**ZONING AMENDMENT
& SUBDIVISION STAFF REPORT****Date: February 7, 2013****APPLICANT NAME**

Savell Subdivision

Subdivision to create 2 lots, and Zoning to rezone the site from R-1, Single-Family Residential, to B-1, Buffer Business, to allow an antique shop.

SITE PLAN

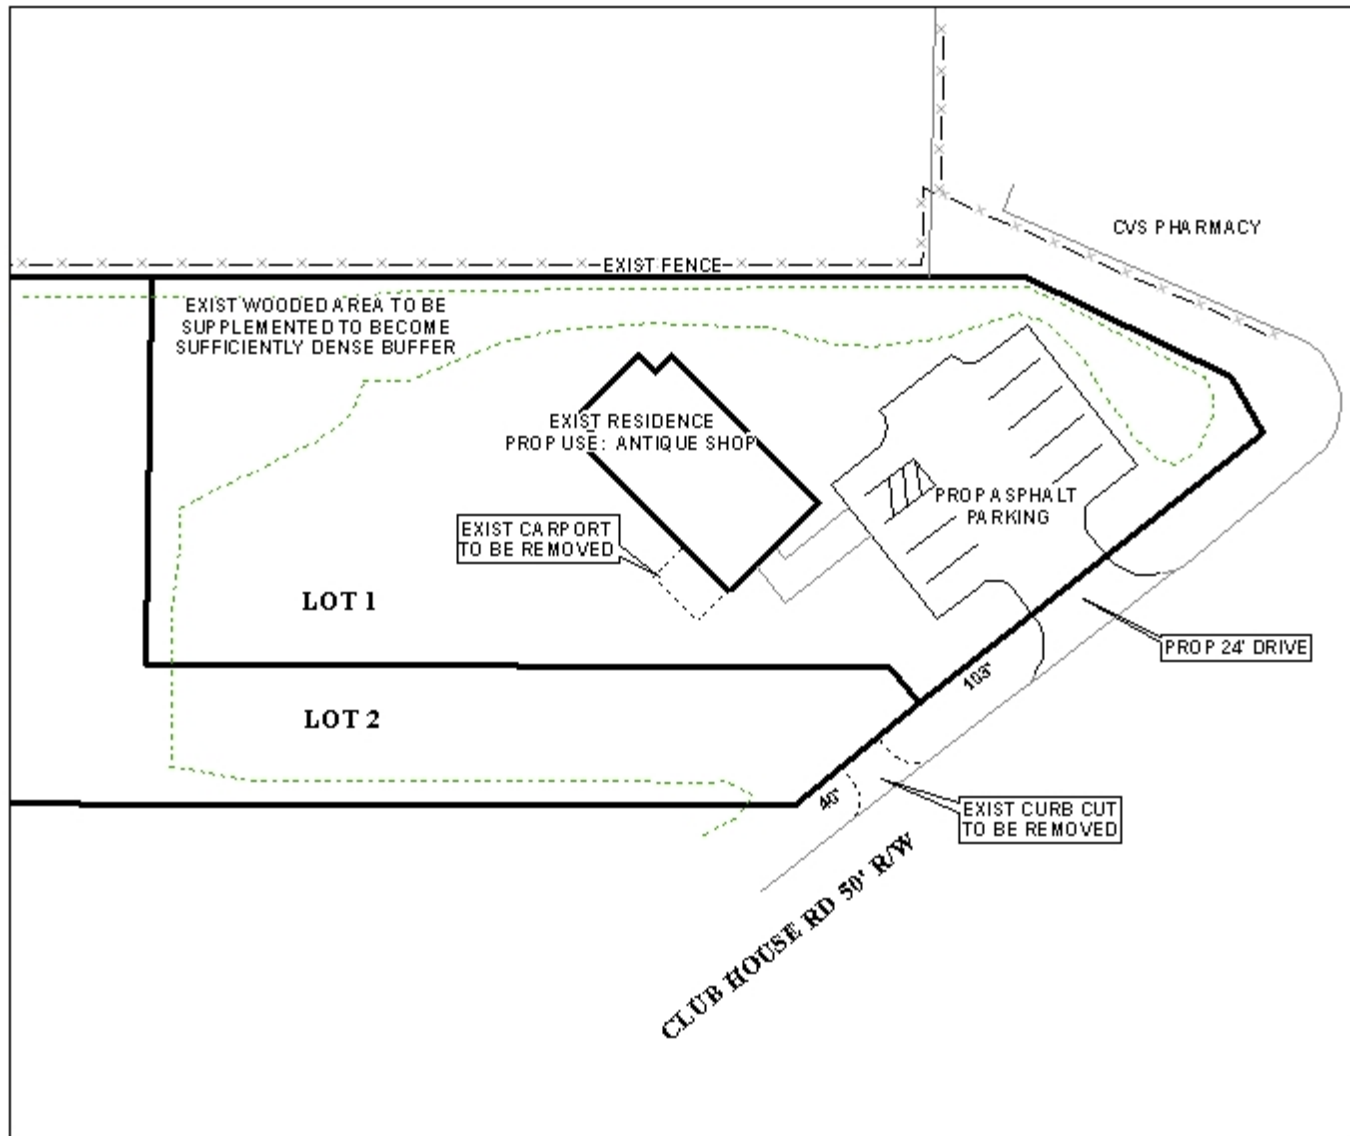
The lot sizes are not labeled in square feet or acres, however the proposed lots appear to exceed to minimum size as set forth in Section V.D.2. of the Subdivision Regulations. If approved, the lot sizes in square feet and acres should be labeled on the Final Plat.

The proposed configuration of the lots will result in Lot 2 becoming a flag lot, of which there is only one in the area, making them an uncommon feature. Furthermore, the proposed Lot 2 does not meet the standards for width-to-depth ratio. Section V.D.3. of the Subdivision Regulations states that lot depth should not exceed 3.5 times the width of the lot at the building setback. As proposed, Lot 2 will be 140' wide at the setback line and 580' deep, resulting in a lot that is approximately 90' deeper than would normally be allowed.

The site plan illustrates both lots having shared access through a 24' wide curb cut on the proposed Lot 2. Because the applicant is proposing to have shared access between two building sites, a Planned Unit Development will be required. This proposed shared access in combination with the proposed Lot 2 being a flag lot make Lot 2 undevelopable.

The 25' minimum building setback line is not illustrated. If approved, the Final Plat should be revised to illustrate and label the building setback line.

The applicant has submitted revised site plans which retain the same lot shapes and sizes; however the proposed shared access between the lots has been removed, with a newly proposed curb cut to serve the proposed commercial lot only. The removal of this shared access means the submission of a Planned Unit Development would no longer be required.

The site plan does not illustrate any tree plantings, and it should be noted that the site will be required to provide full compliance with tree planting and landscaping requirements of Section 64.4.E.3. of the Zoning Ordinance.

There is no dumpster illustrated for the site, nor is there a note stating that curbside pickup will be utilized. If approved, the site plan should be revised to illustrate a dumpster compliant with Section 64-4.D.9.c. of the Zoning Ordinance, or to include a note stating that curbside pickup will be utilized.

The site plan indicates an existing wooded area to the North and West of the site which is indicated to be supplemented to become sufficiently dense to serve as a residential buffer. However, there is no indication of a proposed residential buffer for the property proposed to remain residential to the South. If approved, the site plan should be revised to illustrate either a 6' high privacy fence, or a 6' high 10' wide evergreen vegetative buffer in compliance with Section 64.4.D.1. of the Zoning Ordinance for all adjacent residentially zoned or utilized properties.

The size of the structure proposed to be utilized as an antiques retail business is not provided on the proposed site plan, however, based on City of Mobile aerial photography, the structure appears to be approximately 2,000 square feet, therefore requiring 7 parking spaces. The site plan illustrates a compliant 8 parking spaces including a van accessible handicapped parking space.

Subdivision: *The Subdivision request is recommended for Denial for the following reason:*

- 1) lot shapes not in compliance with Section V.D.1. of the Subdivision Regulations; and
- 2) lot width-to-depth ratio not in compliance with Section V.D.3. of the Subdivision Regulations.
